UNITED STATES PATENT AND TRADEMARK OFFICE

APPLICATION NO.	FILING DATE	FIRST NAMED INVENTOR	ATTORNEY DOCKET NO.	CONFIRMATION NO.
09/823,600	03/30/2001	David Chong Sook Lim	17732-3856000	6055

Office Action Summary

DETAILED ACTION

Attachment to Paper No. 18

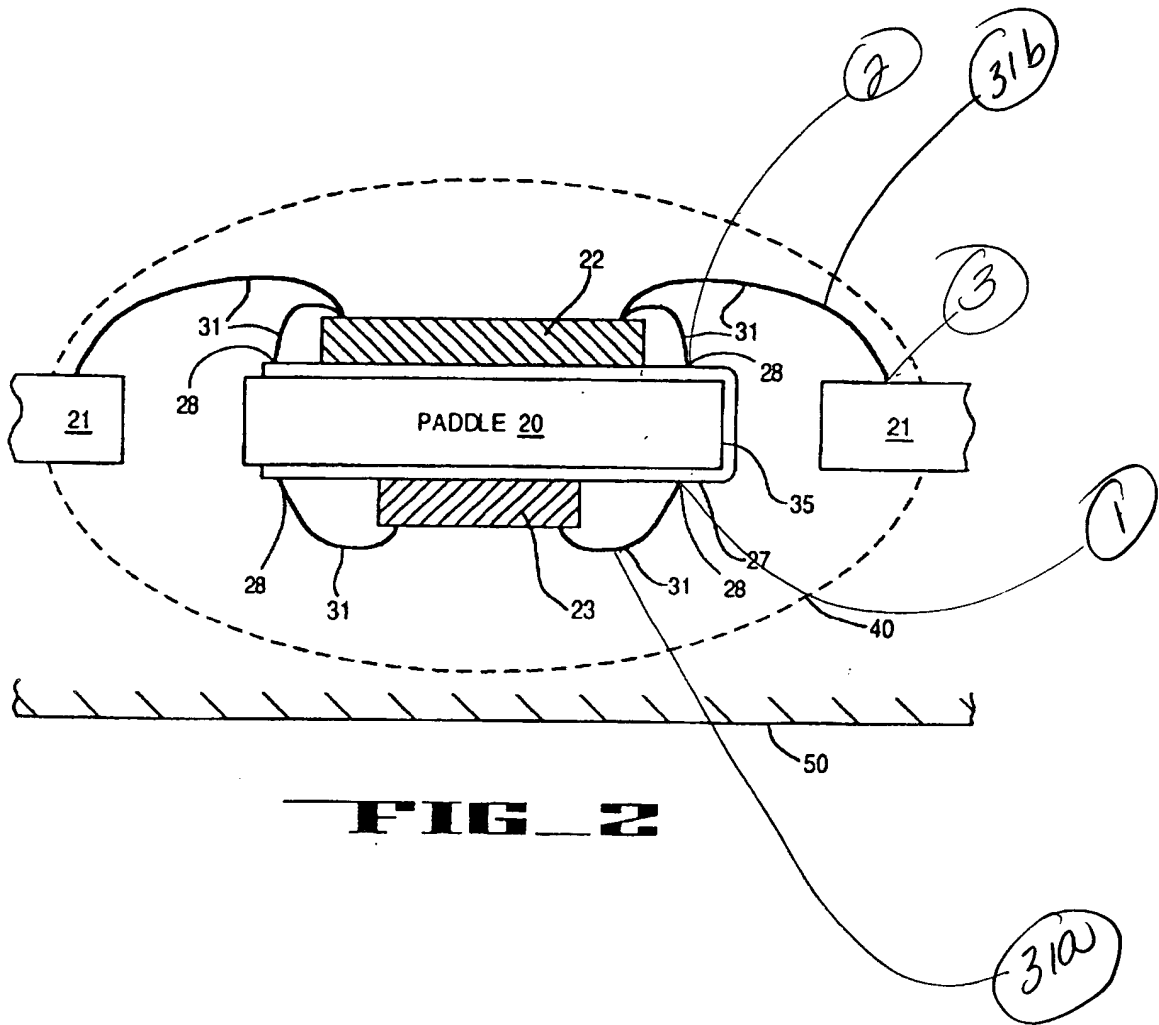
13. Regarding claim 18 (as understood), Kuhn (see attached figure 2) shows a package having a substrate (21, 20, 27) comprising a plurality of leads conductive leads (the wiring of the circuit 27) defining first contacts 1 which are arranged to accept electrical connections from the electrical contacts of a die down die 23. Also, Kuhn shows second contacts 2 which are arranged to correspond to a die up die 22.

14. Regarding claim 19 (as understood), Kuhn shows electrically conductive wires 31a joining electrical contacts of the die down die to the first contacts on the substrate. Also, Kuhn teaches that the substrate includes third contacts 3 which are arranged to

make electrical connection to the die up die 22, and electrical conductive wires 31b joining the second and the third contacts.

19. Regarding claim 32 (as understood), Kuhn (see attached figure 2) shows a package having a substrate (21, 20, 27) comprising a plurality of conductive leads (the wiring of the circuit 27) defining first contacts 1 which are arranged to accept electrical connection from the electrical contacts of a die down die 23, and second contacts 2 which are arranged to correspond to a die up die 22. Also, the Kuhn shows third contact leads 3, and electrical connections 31b connecting the third and second contacts.
